**UNITED STATES
NUCLEAR REGULATORY COMMISSION**
REGION II
245 PEACHTREE CENTER AVENUE NE, SUITE 1200
ATLANTA, GEORGIA 30303-1257

SUBJECT: MEETING SUMMARY – CATEGORY I – REGULATORY CONFERENCE
VIRGIL C. SUMMER NUCLEAR STATION, UNIT 2, DOCKET NUMBER 52-027

V.C. SUMMER NUCLEAR STATION UNIT 2 REGULATORY CONFERENCE

Location of Critical Sections

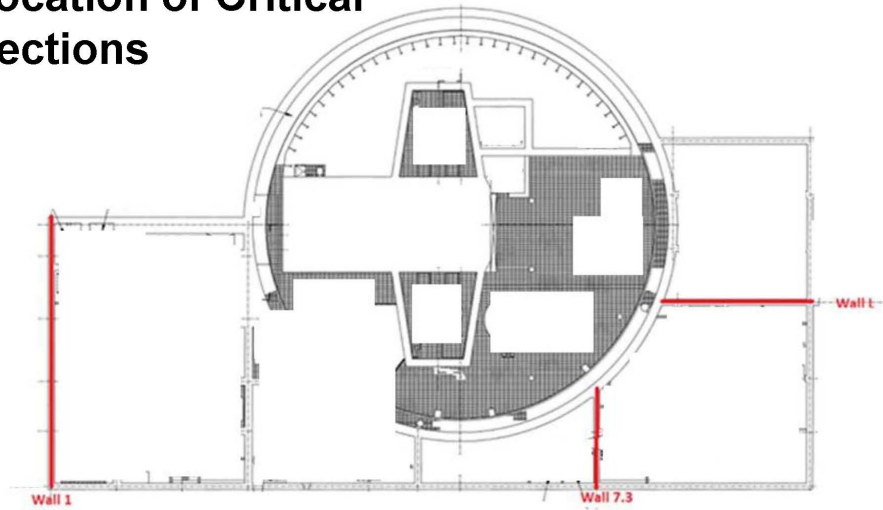
- Critical Section Evaluation
 - 14 critical sections defined by UFSAR Table 3.3-7
 - As depicted in APP-1000-S3R-005, these sections were evaluated based on the following
 - Where drawings have been issued certified for construction (CFC)
 - Where out-of-plane shear reinforcement is required
 - Where American Concrete Institute (ACI) 349-01 shear tie spacing requirement of $d/2$ is not met
 - Where ACI 318-11 development of headed shear tie to mid-depth of wall is not met
 - Three critical sections were identified for further evaluation
